# CITY OF ALBUQUERQUE

**RE: Main Event, Albuquerque Carpenters Training Center, Pan American Freeway  
and Vassar Drive  
Grading Plan and Drainage Plan  
Engineer's Stamp Date 5-14-2015 (File: G16-D149)**

**RE: MAIN EVENT,  
PAN AMERICAN FREEWAY AND VASSAR DRIVE  
GRADING PLAN AND DRAINAGE PLAN  
ENGINEER'S STAMP DATE 3-27-2015 (FILE:G-D149)**

Please find the following responses addressing your comments listed below:

MAIN EVENT		DRAWN BY
PAN AM FREEWAY AND VASSAR AV.		BJF
GRADING PLAN		DATE
		05/14/15
		2015015_GRB
		SHEET #
		C5
		JOB #
		2015015

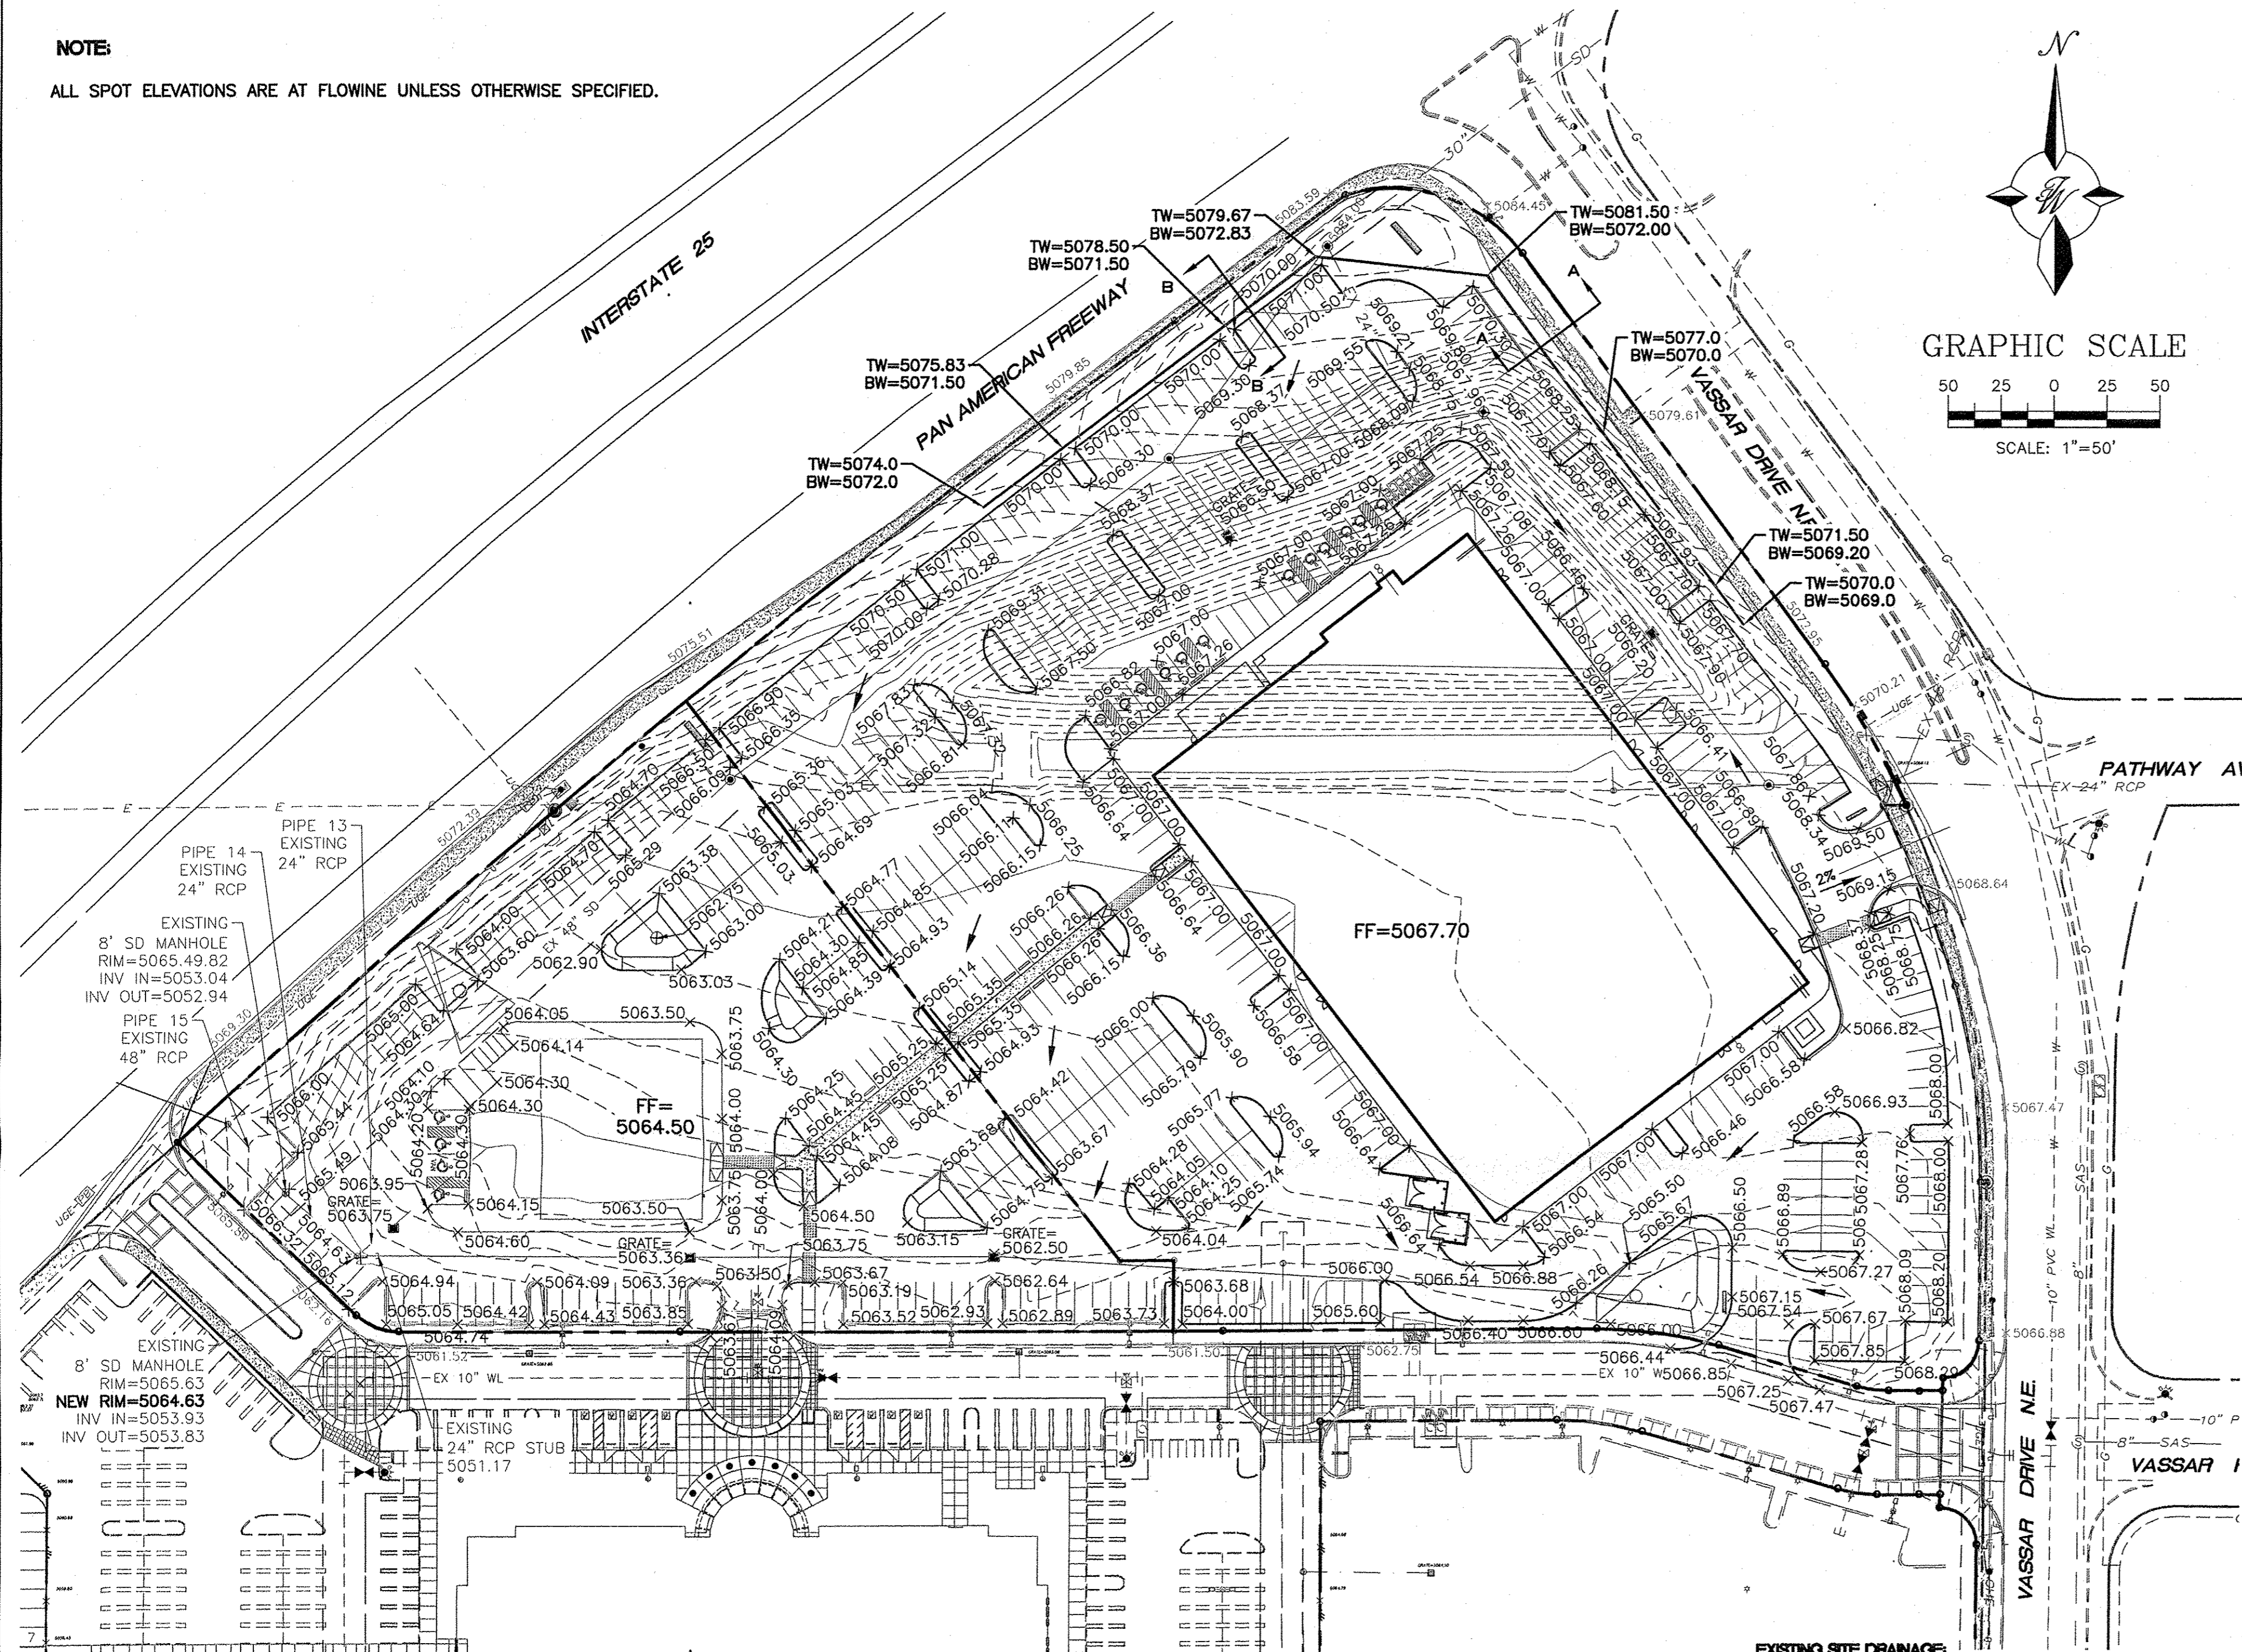
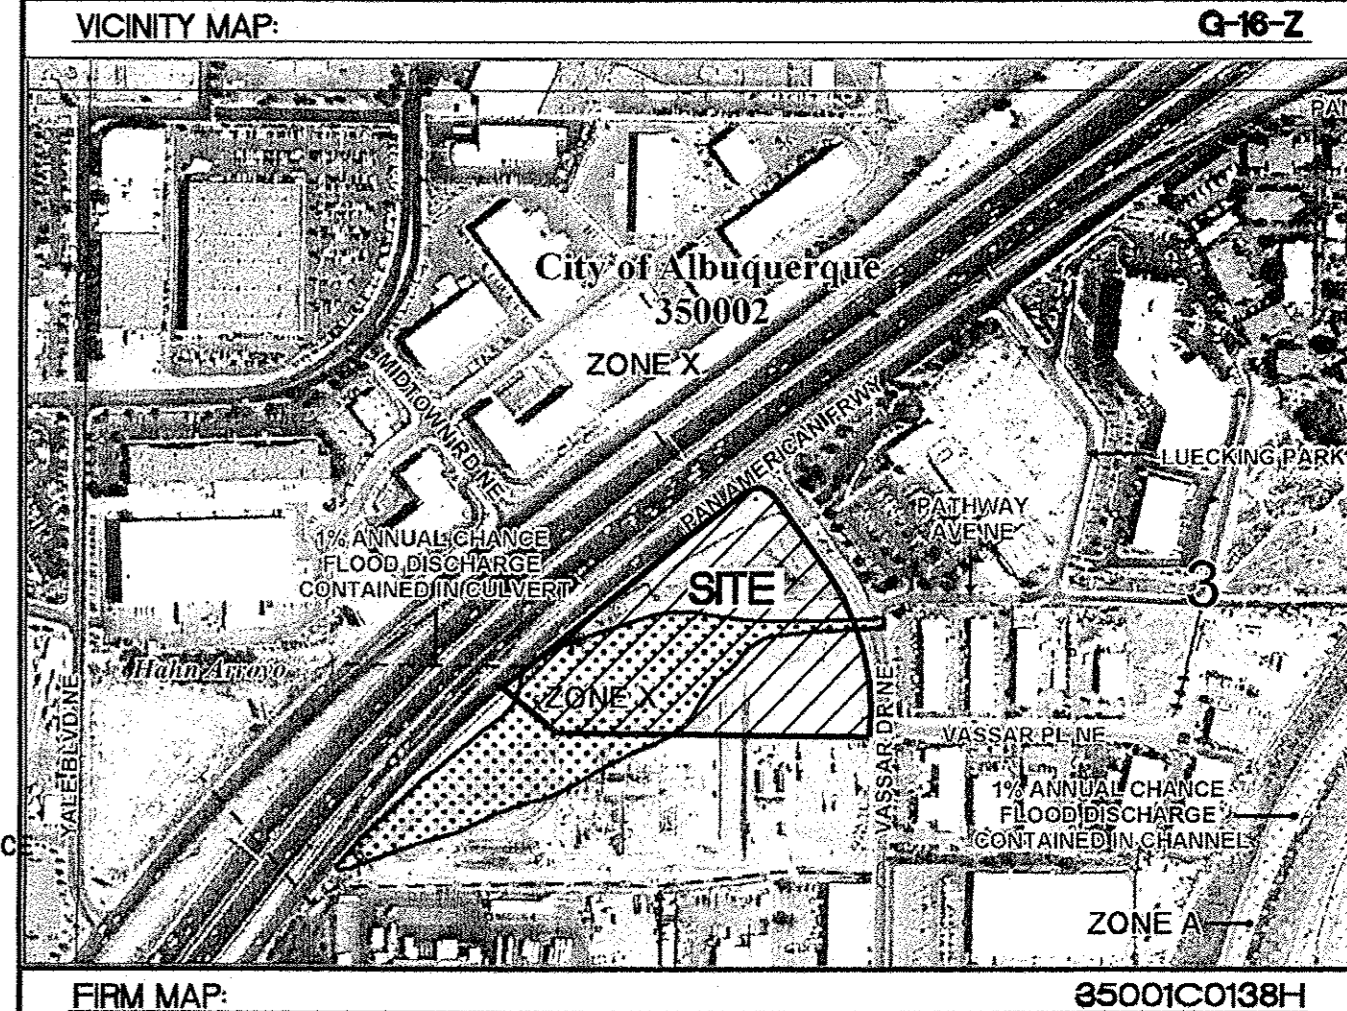
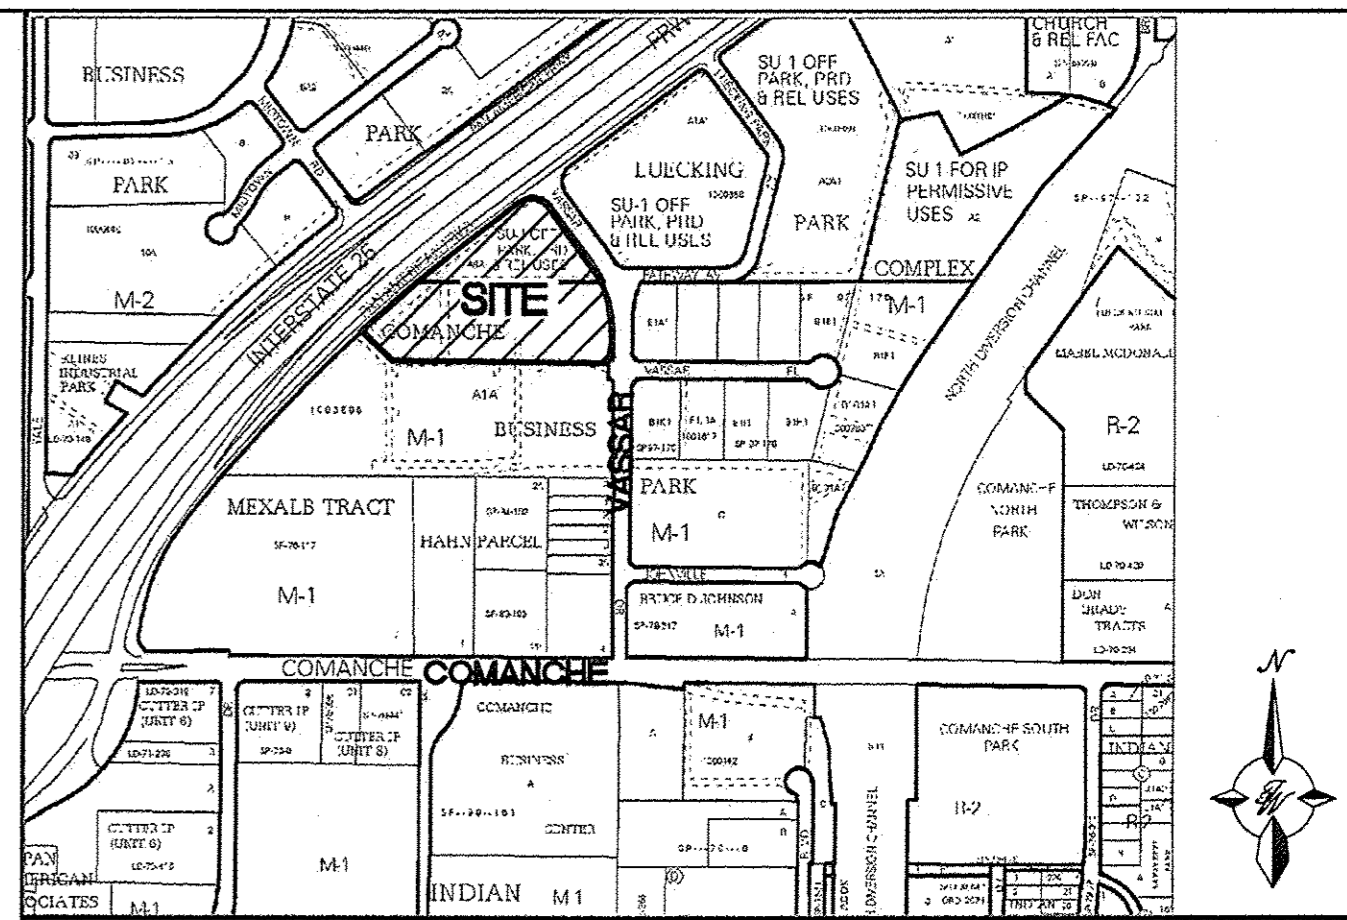
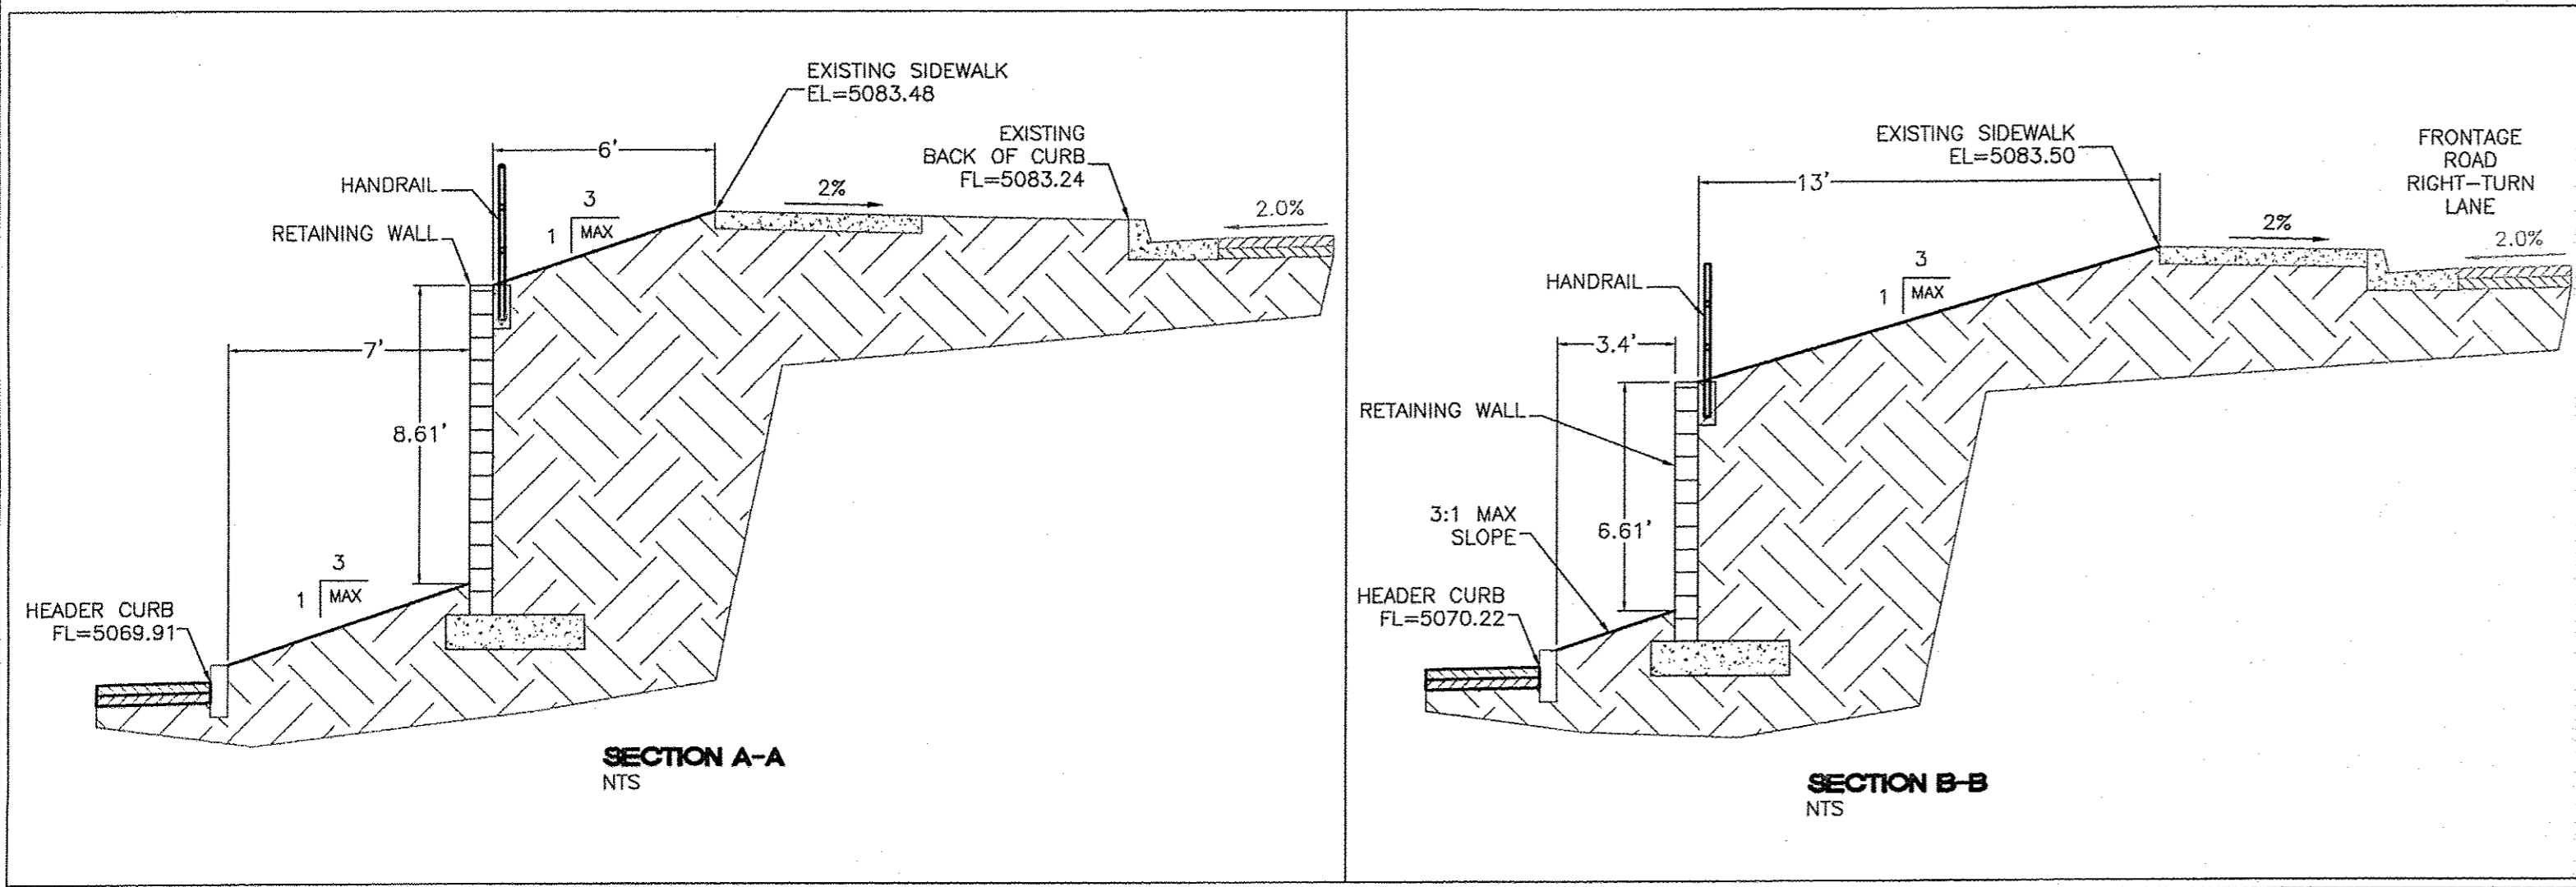
2. In the "Carpenters Training Center Drainage Report" where 159.55 fs was approved for discharged from the site that included 16.68 cfs from the Carpenter's Training Center, this amount was said to include "127.4 cfs from the existing retention pond, 13.01 cfs from I-25 and only 18.68 cfs from the existing retention pond, 13.04 cfs from I -25 and only 18.68 cfs from the Carpenter's Center". In your drainage narrative for this plan, include discussion of all on-site and off-site flows contributing to the downstream storm drain system that was constructed as part SAD 216. Include excerpts from previous drainage reports within the next submittal including the storm cad profiles from the Carpenters Training Center Report" (but with flows labeled on the profiles) and the original SAD 216 Map #4 and Table 1 Showing the analysis points and corresponding acceptable flows for the downstream system. Also explain difference between the 159.55 cfs versus the 101 cfs originally shown for SAD 216 at Analysis Point 3 for that report. Please put discussion into a report format for this large of a site. **As we discussed on the telephone this information was added to the drainage narrative on Sheet C5.**

5. Check the middle entrance to the private drive south of the building with regard to grade elevations. A couple of new spot elevations are shown to be 3 feet off from existing spot elevations, creating a very steep drop. Include more existing spot elevations within the public and private roads surrounding the site. **There is no middle entrance. The existing entrance is being eliminated. A note was added to show that we are adding curb and gutter in this location to make it clearer.**

7. It looks like an approximate 3:1 slope is being crated between the Pan American Freeway and the retaining wall along the parking lot. Provide Section A-A symbol on the plan view. There is an elevation discrepancy where the top of wall elevation is 5079.67, and there is an existing 5084.0 spot elevation as well as a 5086.90 for new manhole rim elevation within very short distance from the wall. **Section A-A was already shown for the cross-section on Vassar Drive so Section B-B was added on Sheet C5. The manhole rim elevation was corrected.**

9. Specify elevations in parking lot to be at bottom of curb if this is the case. **A note was added to the Grading Plan stating that all spot elevations are at flow line unless otherwise specified.**
